**AGENDA ITEM:**    **201401601** - 5950 Mitchell Road, *Applicant: Rockhaven Homes*, to rezone from R-1 (Single Family Dwelling District) to R-4 (Single Family Dwelling District) for the development of a 16-lot subdivision, with concurrent variances

Agenda Item: **201401601 5950 Mitchell Road** a request to rezone the subject property from R-1 (Single Family Dwelling District) to R-4 (Single Family Dwelling District) to allow for the development of 16 single family lots, with concurrent variances.

**DEPARTMENT OF COMMUNITY DEVELOPMENT RECOMMENDATION**

**SITE PLAN**

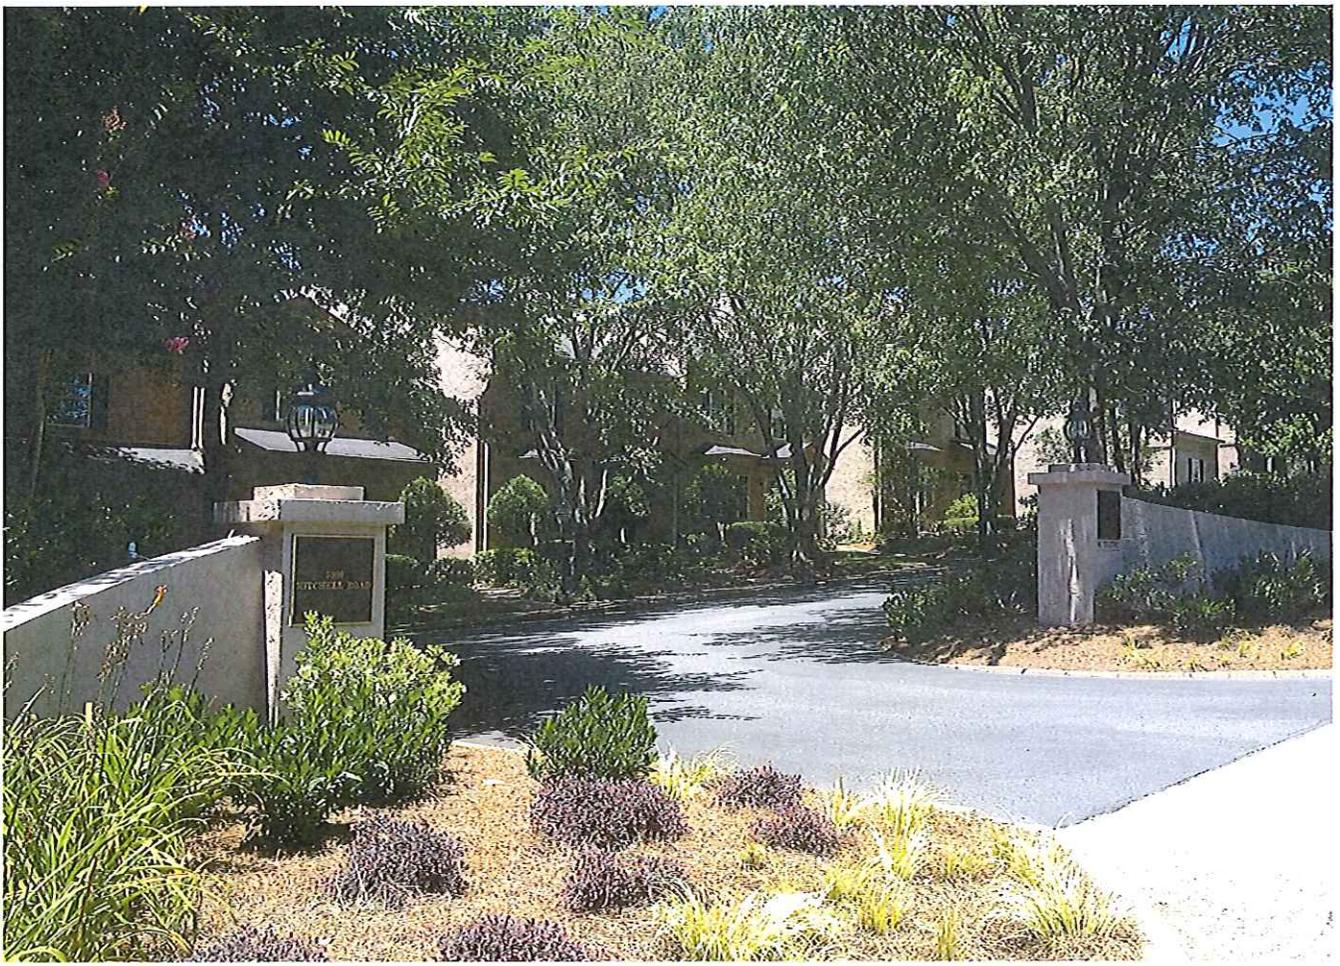
*Staff is of the opinion that the request to reduce the lot width for lots 2, 3, 4, and 5 is not in harmony with the intent of the Zoning Ordinance and could be a detriment on adjacent properties. The lots have been laid out by the developer and could be designed to meet lot width. Additionally, the site does not exhibit any extraordinary or extreme topography to justify the variance request. Therefore, based on these reasons, the staff recommends DENIAL of this variance request.*

Transportation Planner	<p>Mitchell Road is classified a minor street and has a posted speed limit of 25 mph. (Note that zoning site plan has street incorrectly labeled as Mitchell Street).</p> <p>At time of Land Disturbance Permit, site shall meet requirements of Articles 11 and 12 of the Development Ordinance. Based on review of the zoning site plan, please note the following:</p> <ul style="list-style-type: none"> <li>• Street design shall meet design and construction standards, §103-70.</li> <li>• Street frontage along Mitchell Road shall be widened to uniform lane width of 12 feet, §103-73(n).</li> <li>• The minimum cul-de-sac radius is 50 feet, §103-74(c).</li> <li>• The minimum right-of-way for Mitchell Road is 50 feet (existing right-of-way is not show). Applicant shall dedicate right-of-way along entire property front of 25 feet from street centerline, 11 feet behind back of curb, or one foot behind sidewalk, whichever is greater, §103-75(a). Ten foot right-of-way miters are required at Mitchell Road and proposed street §103-75(b).</li> <li>• The corner lots shall have access on Mitchell Road.</li> <li>• Proposed street and driveways shall meet intersection sight distance of §103-77(f).</li> </ul> <p>All existing and proposed street frontages shall meet curb and gutter requirements §103-79.</p>

I would also like to voice a strong objection to location of the proposed retention pond. As shown on their plans it would be contiguous to my property and would become the dominant view from my back windows and deck. It does not even appear to have a set back as a normal lot would have. I believe that at a minimum it should be between lots in the new development with the same setbacks as any other lot, and it should have heavy, mature landscaping as a buffer. An even better solution would be to put it in the center of the development and build it as a water feature. It seems inappropriate to hide it away in the new subdivision and have that be at the neighboring homes expense (because of a drop in our homes resale value). On my recent visit to a new Rockhaven development I took a picture of their retention pond and that picture is both below and attached. I took this picture immediately after the Community/Developer Resolution meeting on Thursday, June 26, 2014. This looks terrible now and will look even worse after the weeds grow out of control. There is also the possibility/probability of odors, snakes, rodents, etc. This view would diminish the value of my home and that of my neighbors.
